HUMAN FACTORS ASSESSMENT: M9 ARMORED COMBAT EARTHMOVER (ACE)

Gregory S. Krohn
Essex Corporation

REPORT DOCUMENTATION PAGE		READ INSTRUCTIONS BEFORE COMPLETING FORM																
1. REPORT NUMBER ARI Research Note 88-12	2. GOVT ACCESSION NO.	3. RECIPIENT'S CATALOG NUMBER																
4. TITLE (and Subtitle) Human Factors Assessment: M9 Armored Combat Earthmover (ACE)		5. TYPE OF REPORT & PERIOD COVERED Final Report February 1983 - December 1985																
7. AUTHOR(s) Gregory S. Krohn		6. PERFORMING ORG. REPORT NUMBER																
9. PERFORMING ORGANIZATION NAME AND ADDRESS Essex Corporation 333 North Fairfax Street Alexandria, VA 22314		8. CONTRACT OR GRANT NUMBER(s) MDA 903-83-C-0033																
11. CONTROLLING OFFICE NAME AND ADDRESS U.S. Army Research Institute for the Behavioral and Social Sciences, 5001 Eisenhower Avenue, Alexandria, VA 22333-5600		10. PROGRAM ELEMENT, PROJECT, TASK AREA & WORK UNIT NUMBERS 2Q263739A793																
14. MONITORING AGENCY NAME & ADDRESS (if different from Controlling Office) - -		12. REPORT DATE April 1988																
		13. NUMBER OF PAGES 185																
		15. SECURITY CLASS. (of this report) Unclassified

Figure 33. Mechanic grasping the paddle lock bracket to open the hatch. (The night vision periscope is in place above the driver's hatch.)

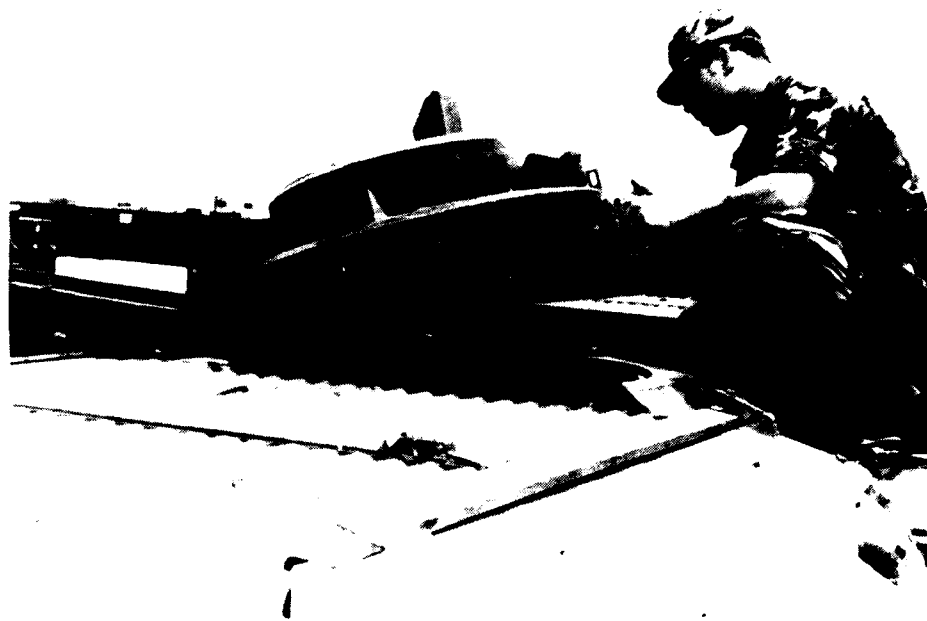
4. Figure 33 shows a mechanic grasping the bracket of the hatch paddle lock. There is no easy way to grasp the hatch in order to open it.
5. Figure 34 shows personal combat gear stowed in the driver's hatch (see Deficiency: Insufficient Stowage Space and Secure Locations for Stowage, pg 49). Using the hatch for stowage adds to the time required to close the hatch in a combat emergency or before firing the smoke grenade launcher.

1. The weight of the hatch should be reduced, or opening and closing the hatch should be mechanically assisted, so that the force exerted by the operator to perform the task is within the limits required by MIL-STD-1472C.
2. The hatch should be opened with a single motion of the hand and arm (MIL-STD-1472C).
3. The vision blocks and other structures in the hatch, or the roof surrounding the hatch, should be positioned far enough from the operators so that their faces cannot strike the objects when they are seated and wearing their seat belts properly.
4. Handholds should be added inside and outside of the hatch to facilitate opening and closing the hatch.
5. The hatch should be sealed when closed to prevent leaks of water or NBC contaminants.

Figure 37. An operator attaching the chain to the ejector blade and positioning it down the center of the dozer blade. (NOTE: The chain passes through the stowage area above the dozer blade.)

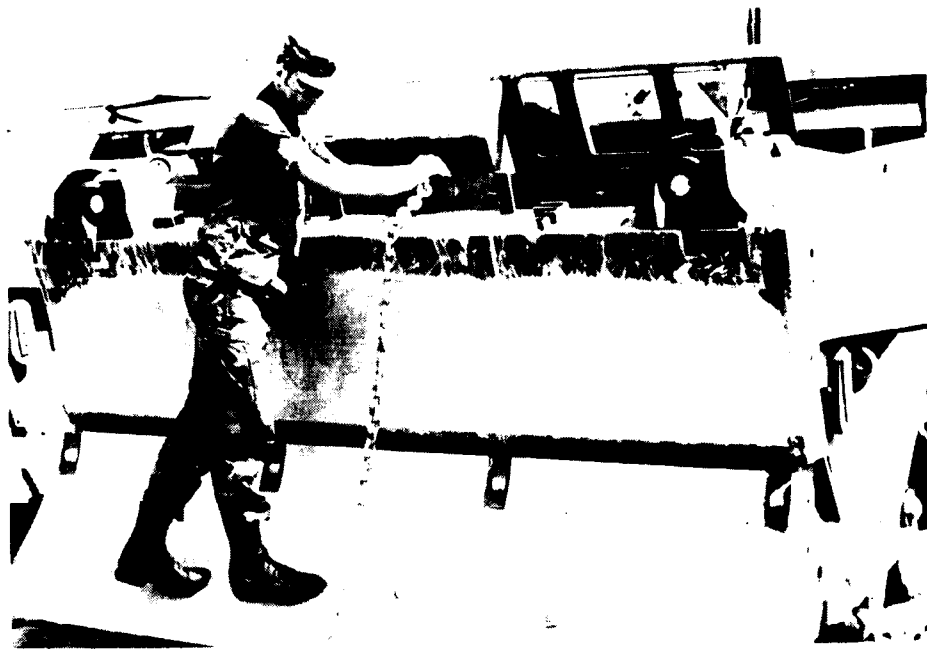
Description of the Safety Hazard: Two operators reported that folding the dozer blade was hazardous. Figure 36 shows an operator crawling beneath the dozer blade in order to attach a chain to a shackle beneath the blade. The vehicle suspension must be raised (sprung) and supported with blocks in order to prevent the dozer blade from descending on the operator as a result of pressure changes in the hydraulic system. The support blocks were unavailable in the field and earth berms, which could collapse, were used to support the dozer blade.

An alternative to the procedures involves raising the apron and dozer blade allowing the operator to stand beneath the dozer blade to attach the chain. However, the additional steps add approximately 15 minutes to the 20 to 30 minutes procedure. The additional time results from removing and replacing the apron pins (see Deficiency: Apron and Dozer Blade Lock Pins, pg 64). Moreover, unless the apron is fully raised and locked with its safety pins (making the shackle difficult to reach) the dozer blade and apron could fall on the operator, again as a result of pressure changes in the hydraulic system.

Figure 39. The crushed rear step and handrail.

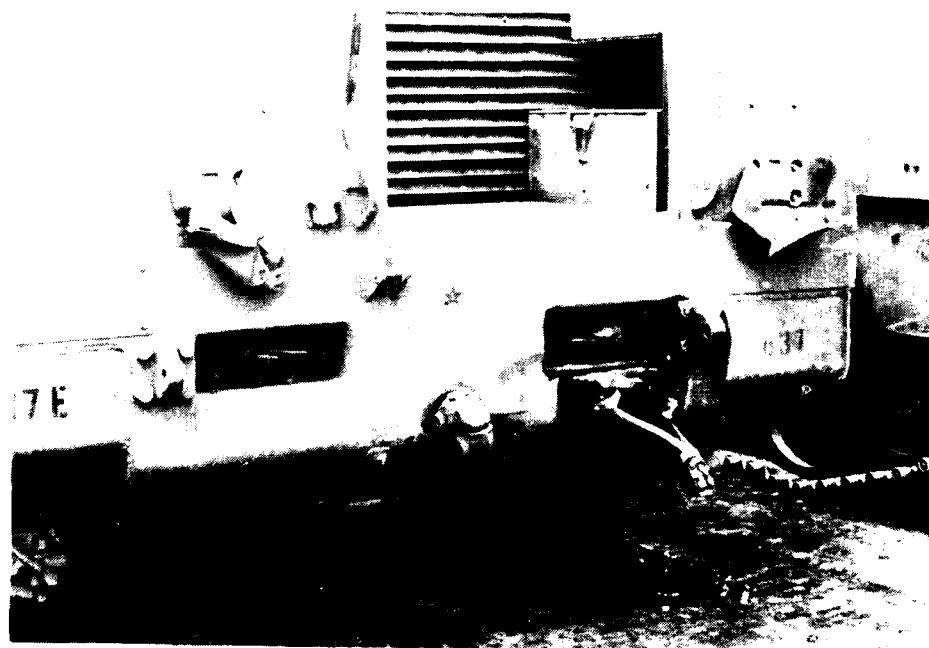
Description of the Safety Hazard: Figure 39 shows the crushed rear steps and handrails on the rear of the M9. The rear lower cable step snagged on objects and the cables and steps were broken. The rear upper platform step was crushed on all the vehicles. The handrails were bent on many of the vehicles. Scraped metal on the handrails had burrs that would stab the operator's hand.

Figure 42. The eight engine grille panels.

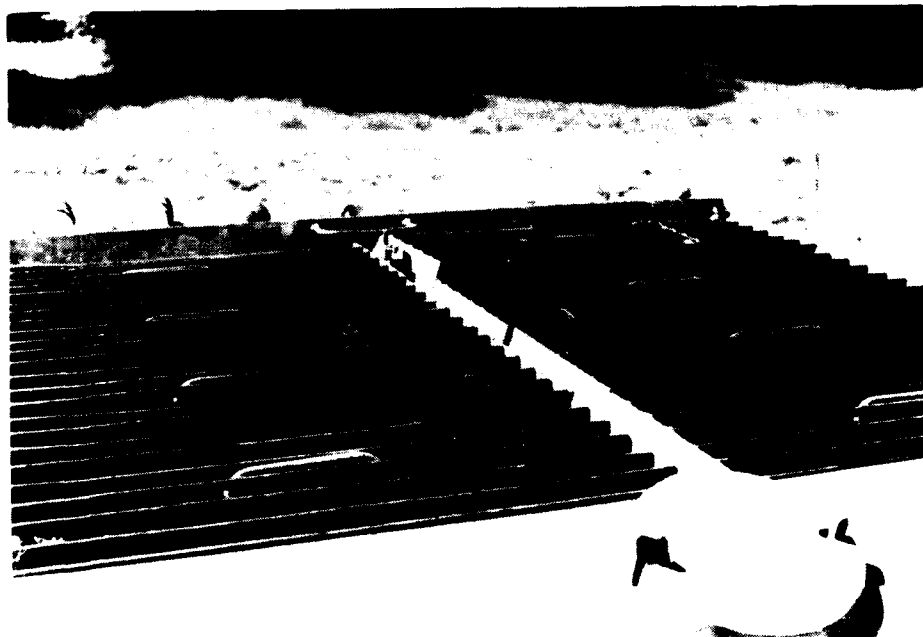
Description of the Safety Hazard: Figure 42 shows the eight engine access grilles in place above the engine. Three mechanics and four operators reported that the weight of the exhaust grilles (approximately 50 lbs (22.6 kg)) discouraged the operators from performing PMCS checks. Moreover, there is no safe way to stand above the grilles to remove them as the surfaces in front and to the rear of the grilles are sloped and slippery (safety hazard).

1. Reduce the weight of the grilles. Use a lighter material for the grilles other than steel (ie., aluminum).
2. Make the grille sections into one piece that is hinged and can be raised and supported like the hood of a truck.

Figure 43. A damaged winch cable and the cable unevenly wrapped on the winch drum.

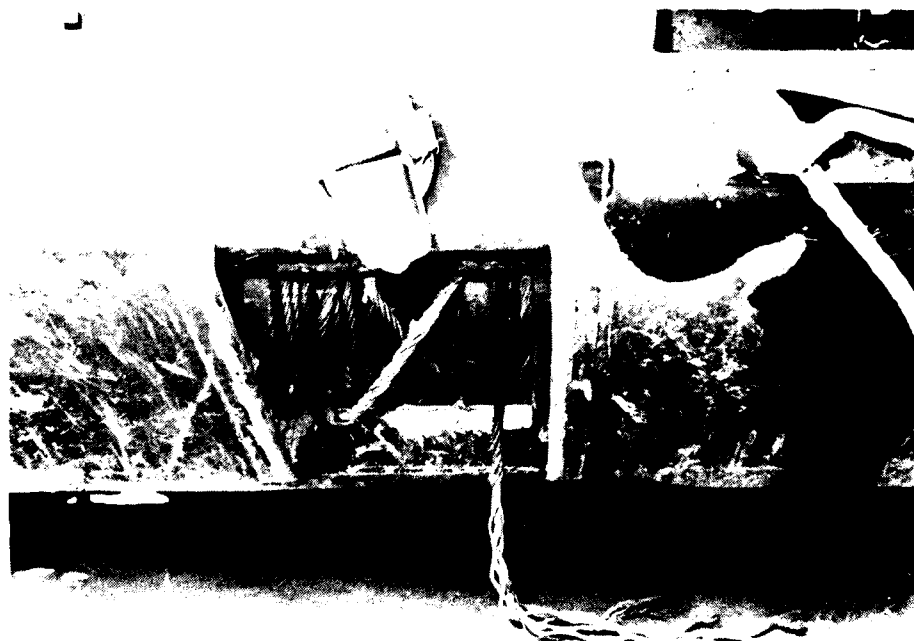
Description of the Safety Hazard: Figure 43 shows a frayed and broken winch cable improperly wrapped on the winch spool. Operators experienced several problems using the winch and many problems resulted in wire rope failure. The problems included:

1. There was no winch brake on the winch.
2. The winch had to be moving in order to shift gears.
3. The winch capacity is only 30,000 lbs, while the vehicle weighs approximately 55,000 lbs, when the bowl is full and the vehicle is likely to become stuck. Most of the wire rope failures occurred during self-recovery operations.
4. The wire rope wrapped itself unevenly on the drum which causes damage to the wire rope. The operators could not see whether the wire rope was wrapped appropriately as the winch was spooling it in.

Figure 48. Fluid lines attached to the engine.

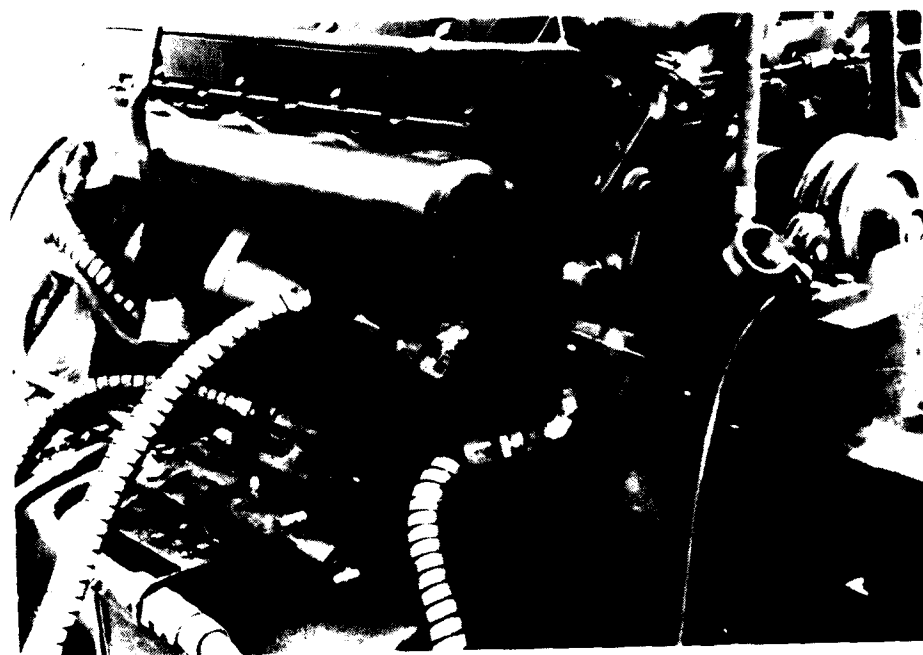
Description of the Deficiency: Figure 48 shows fluid lines connected to the engine manifold. Figure 49 shows hydraulic lines disconnected and tagged with numbered cards. When components are removed from the engine compartment, numerous hydraulic lines are disconnected. Numbered tags are attached to the lines to facilitate reconnecting the lines to their fittings. Two mechanics estimated that nearly 50 percent of the time required to perform maintenance was due to the time required to disconnect and tag lines.

Potential Solutions: Many other military vehicles, such as the AVLB, have color coded hydraulic fittings and quick disconnect hydraulic couplers. Add quick disconnect couplers and a coding system to the hydraulic lines and fittings. The coding could be colors or numbers that match on the lines and the fittings they are connected to. Color codes are easy to identify. Numbers, however, can also be used as parts numbers when new lines and fittings are ordered. Moreover, the numbers can also be used in maintenance manual diagrams as reference numbers.

Figure 52. The location of the battery box below the radio box and behind the radiator grille.

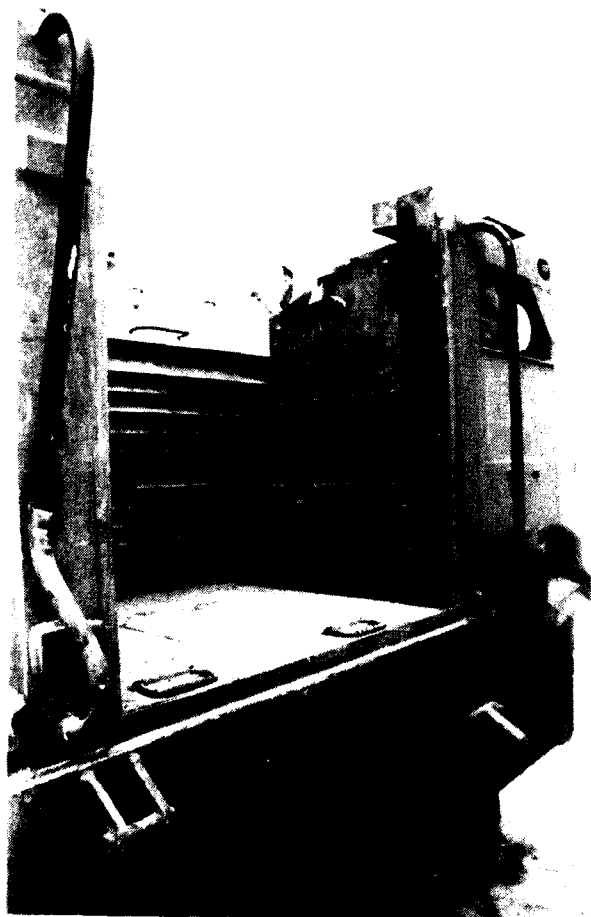
Description of the Deficiency: Figure 52 shows the battery box located beneath the radio box at the rear of the M9. Three operators and four mechanics reported that they could not see into the furthest battery ports or inspect the terminals because their view and reach were blocked by the radio box. The radio box is approximately 12 in (29 cm) above the batteries. The limited space also makes removing and replacing the batteries difficult.

Implications for the Mechanic, the Operator, and the Equipment: The battery fluid was frequently low due to the high temperatures created by the muffler and the radiator. The low fluid levels were often not detected during daily PMCS maintenance checks. Damage to the batteries may result.

Potential Solutions: The radio and batteries may need to be relocated. High temperatures generated by the muffler and radiator damaged the equipment during the test. If the hatch and driver's station are reconfigured, the radio might be placed in the driver's station and the battery box might be located above the fuel tank.

Figure 53. A mechanic reaching between the roadwheels to position the dog bone jack.

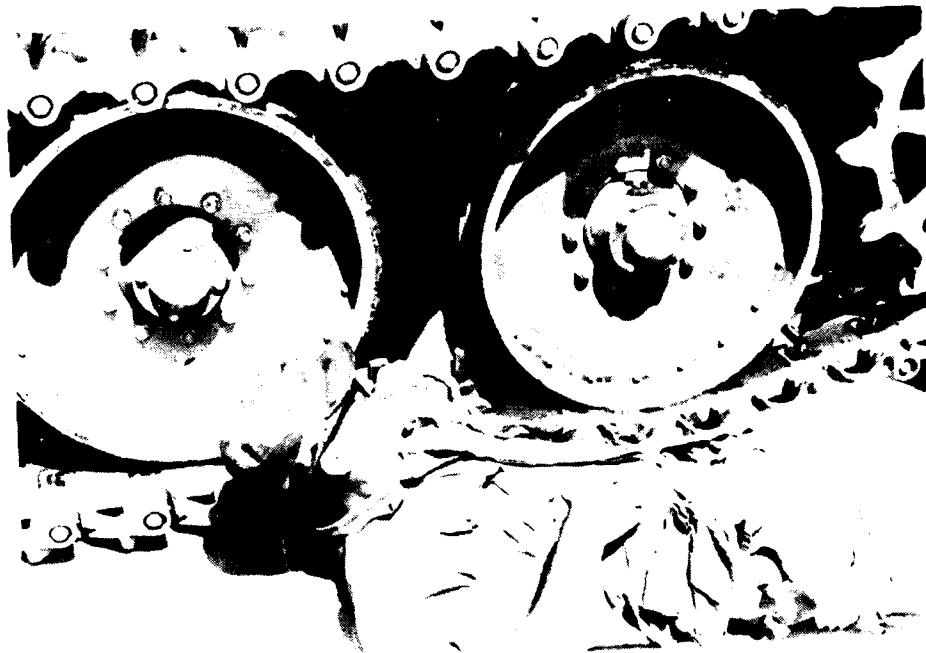
Description of the Safety Hazard: Figure 53 shows a mechanic reaching into the roadwheels in order to hold a dog bone jack in place between the upper and lower portions of the track. Figure 54 shows the dog bone jack.

1. Use the hydraulic jack only on hard paved surfaces.
2. Modify the dog bone jack to make it self-standing during positioning of the vehicle. This might be done by adding a hinged bipod to one side of the jack. The bipod would angle outward from the jack and wedge into the ground, creating a tripod of the jack.
